SERVICE BULLETIN 0807-001
3-30-2009, Revision A

MULTI-GROOVE SUPERCHARGER BELT

Figure 1

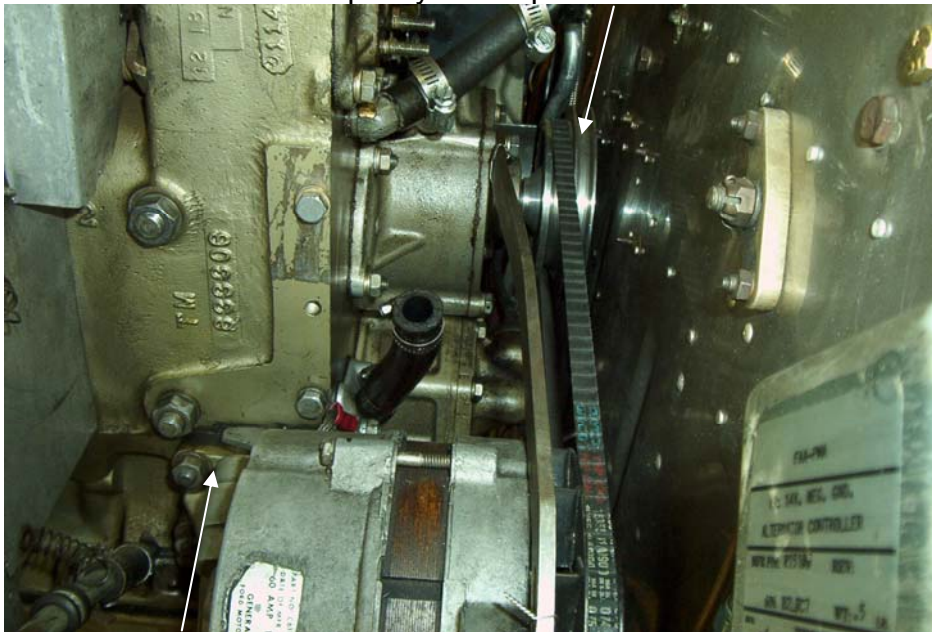
1. Disconnect the battery.
2. Remove the upper and lower cowling.
3. Loosen the engine mount bolts at the firewall and using a hoist, slide the engine forward about 2 inches.
4. Loosen the supercharger idler and remove the supercharger belt and loosen the alternator and remove the alternator belt. Remove the alternator and remove the 4 nuts and washers securing the alternator support to the engine remove and modify the support per FAT Inc. drawing P/N 182LR0116, or P/N 182LR0017, or P/N 182LR0018 as appropriate. (figure 1)
5. Reinstall the modified alternator support and alternator.
6. Remove the alternator/supercharger drive pulley from the rear of the engine and replace it with the new double pulley, P/N182LR014-2, using the existing hardware. Tighten to 37.5 to 41.2 ft. lbs. (Figure 1)

Remove drive pulley and replace with P/N 182LR014-2

Figure 2

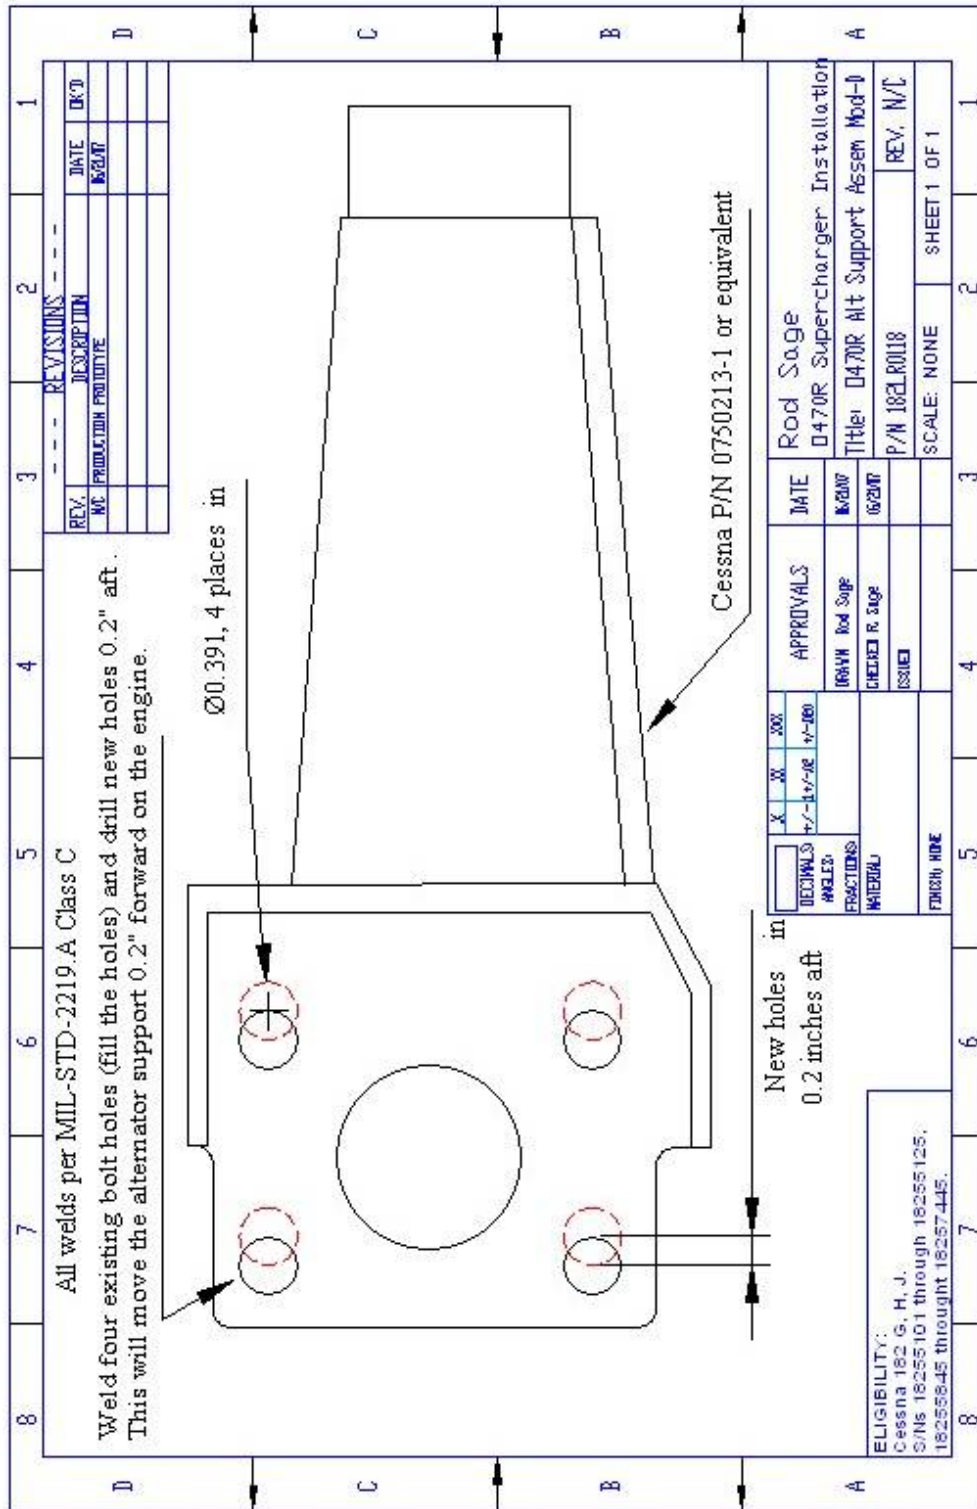
7. Reinstall the alternator belt, FAT P/N 182355, and tighten the belt by rotating the alternator. (Figure 1)
8. Remove the supercharger pulley (figure 2) and replace it with pulley P/N 182LR009-2 using the existing hardware.
9. Install the supercharger belt, FAT P/N182LR440-M or 182U450-M, and tighten the belt by pushing down on the idler pulley, tensioning the belt . Tighten the belt until a 9.5 lb. pull at the center of the lower portion of the belt results in a .25 inch of belt deflection. Recheck belt tension in the first 2-10 hours and adjust to a setting of 7.0-8.0 pounds.
10. Reinstall the engine and confirm clearance of all cables, hoses, wires, etc.
11. Reconnect the battery.
12. Check engine operation with a ground run.
13. Reinstall the cowling.

Remove supercharger pulley, replace with P/N 182LR009-2

APPROVALS	DATE	ROD SAGE
DRAWN	10/20/07	ROD SAGE
CHECKED	10/20/07	ROD SAGE
ISSUED		
TITLE: D470R Alt Support Assem Mod-1-5		REV: N/C
P/N 182L0017		SCALE: NONE
SHEET 1 OF 1

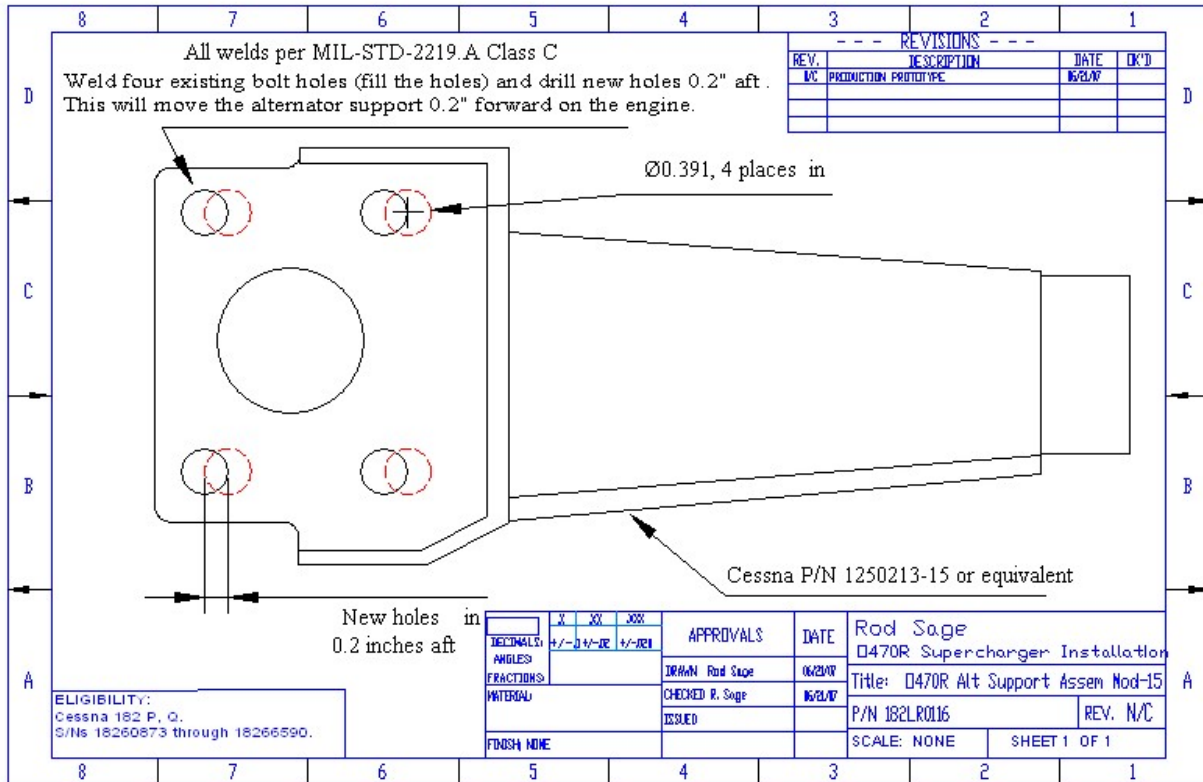
1. After step 6 remove the alternator and remove the 4 nuts and washers securing the alternator support to the engine (figure 1), remove and modify the support per FAT Inc. drawing P/N 182LR0116, or P/N 182LR0017, or P/N 182LR0018 as appropriate. Reinstall the modified alternator support and alternator.
